# CITY OF ALBUQUERQUE

**Re: Menaul Donut Shop  
Civil Site Plan  
Engineer's Stamp 2-23-24 (H19D094)**

CIVIL SITE PLAN

CC-100

TRAFFIC CIRCULATION  
LAYOUT APPROVED

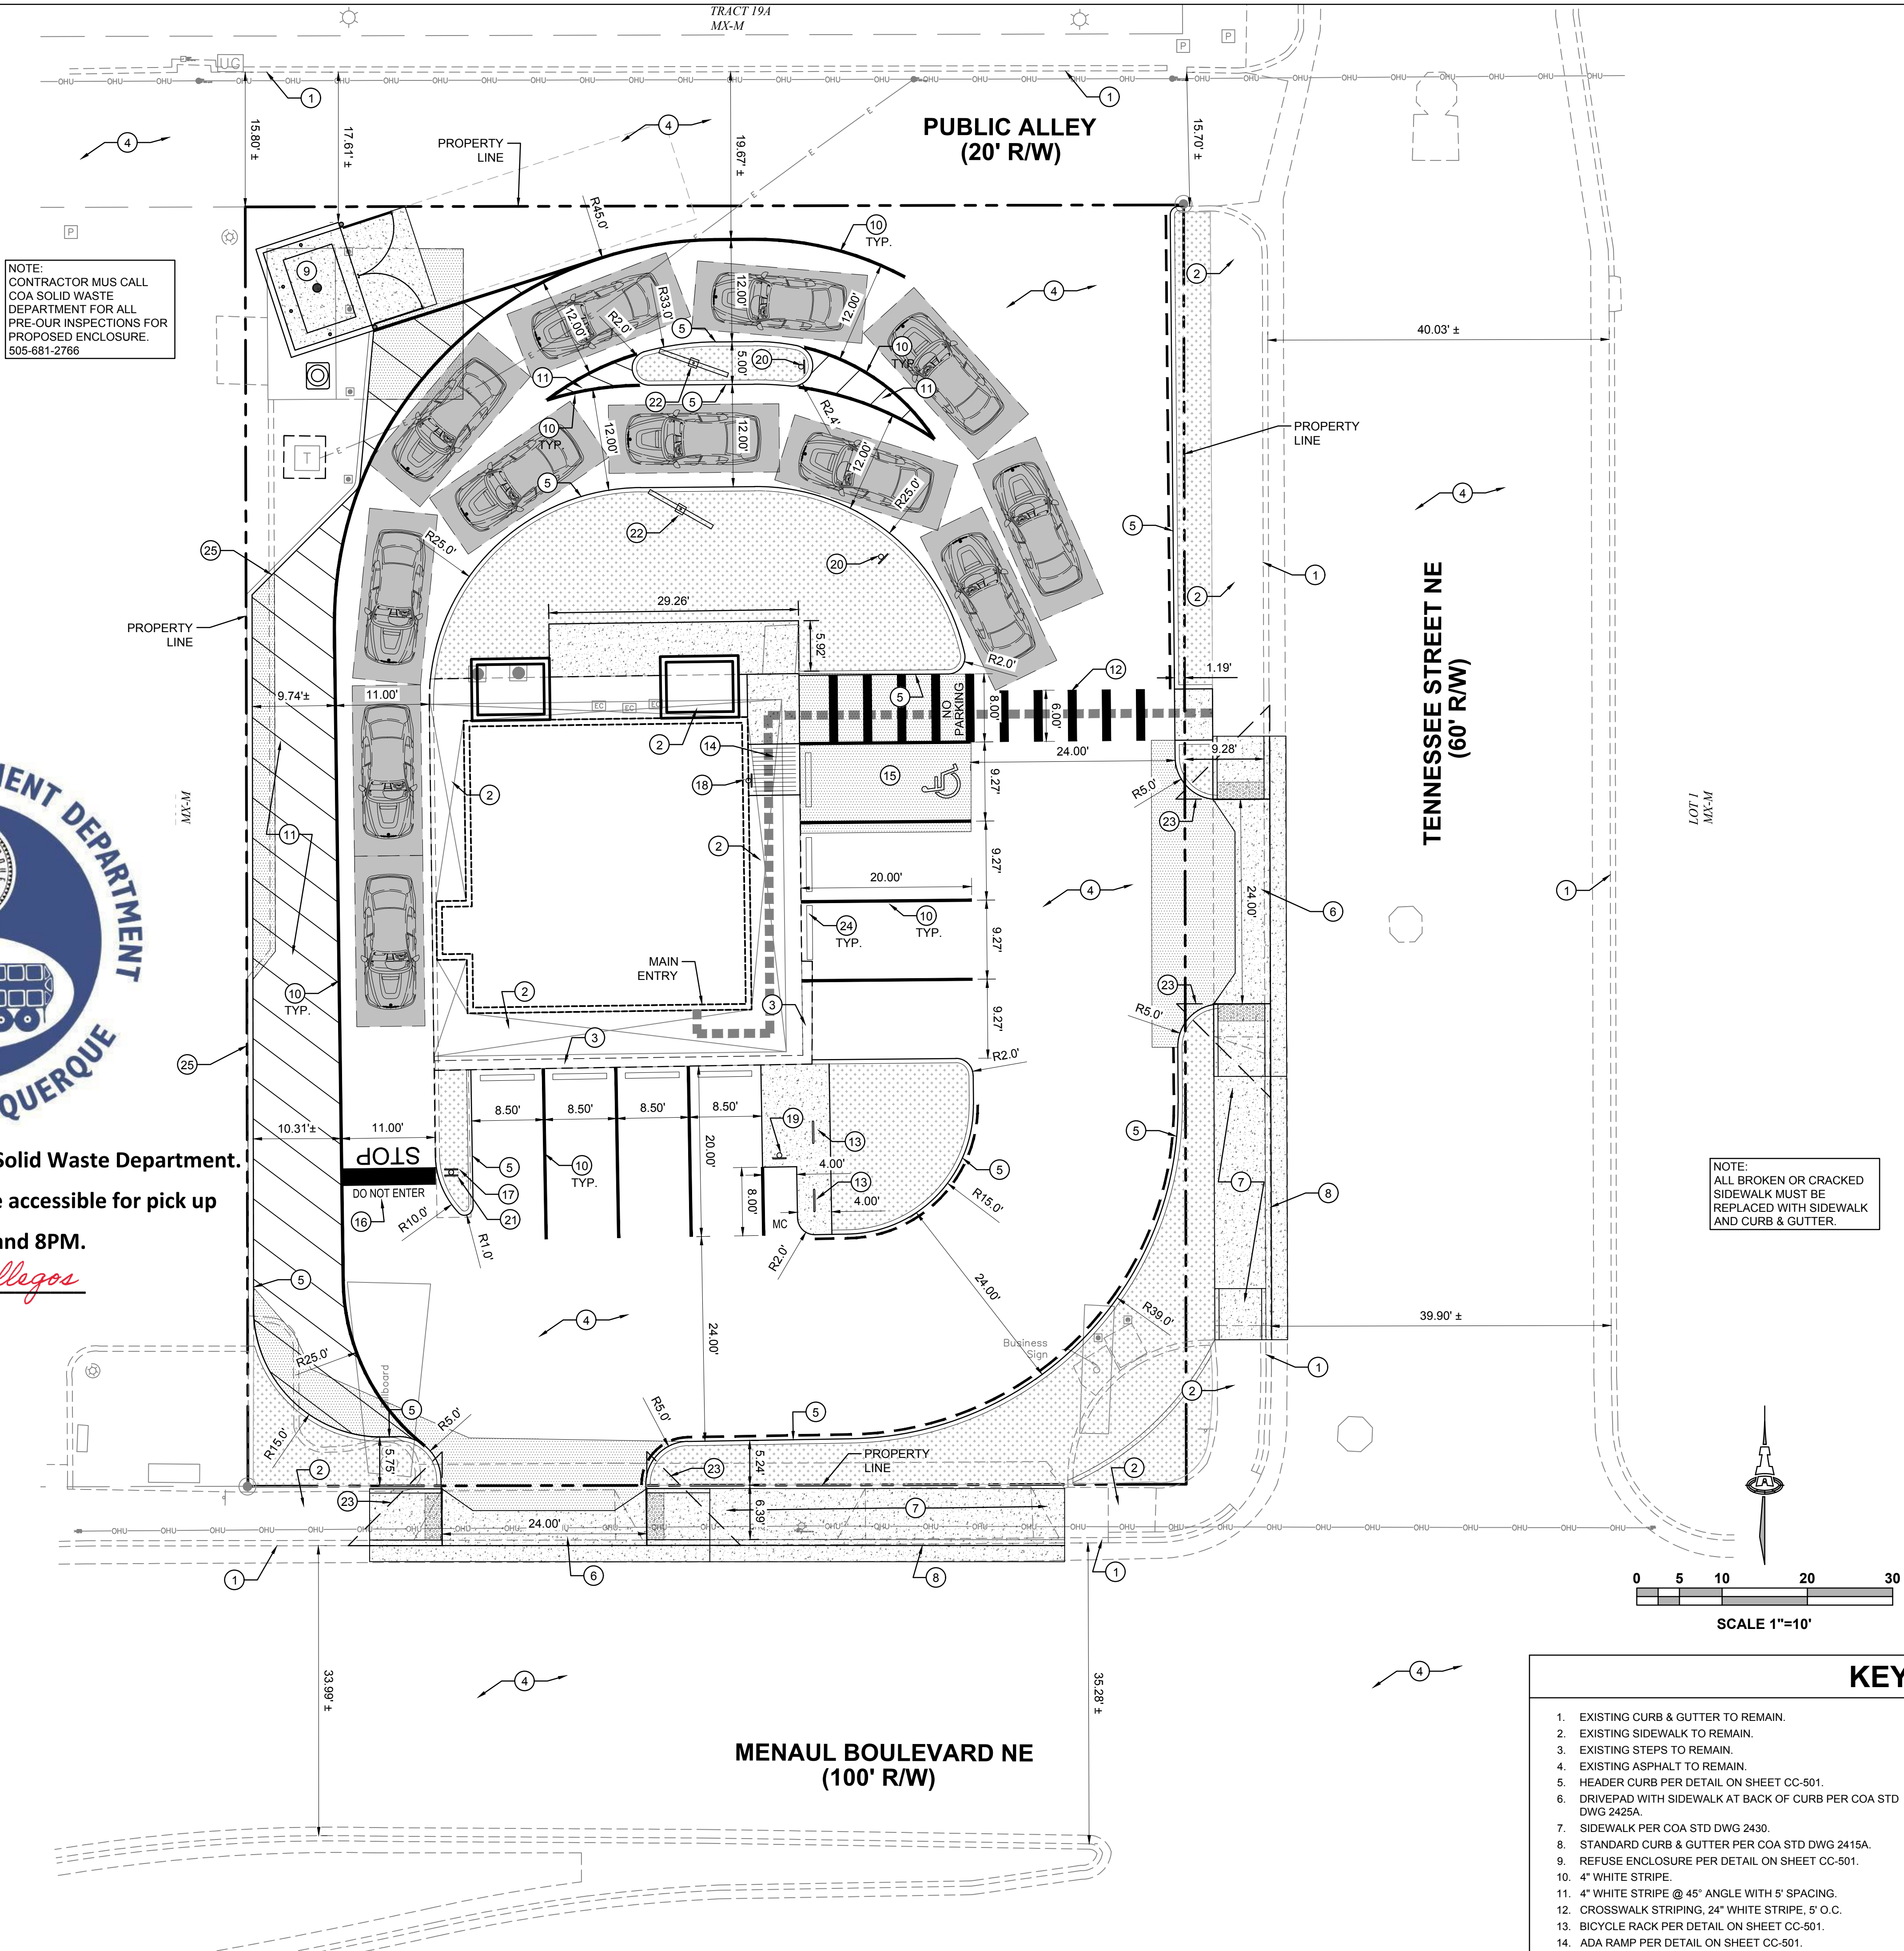
We received a comment that the TCL needed to be re-reviewed and approved because made some minor revisions to the parking along the east side of the building.

Is this correct or are these changes just handled as redline markups during the TCL certification?

Approved for access by the Solid Waste Department.  
All containers must be made accessible for pick up  
between the hours of 5AM and 8PM.  
Reviewer: *Herman Gallegos*  
Date: 03-12-24  
\*\*Recycle Declined\*\*

The TCL submittal received 3-19-24 is approved for Building Permit by Transportation. A copy of the stamped and signed plan will be needed for each of the building permit plans. Please keep the original to be used for certification of the site for final C.O. for Transportation.
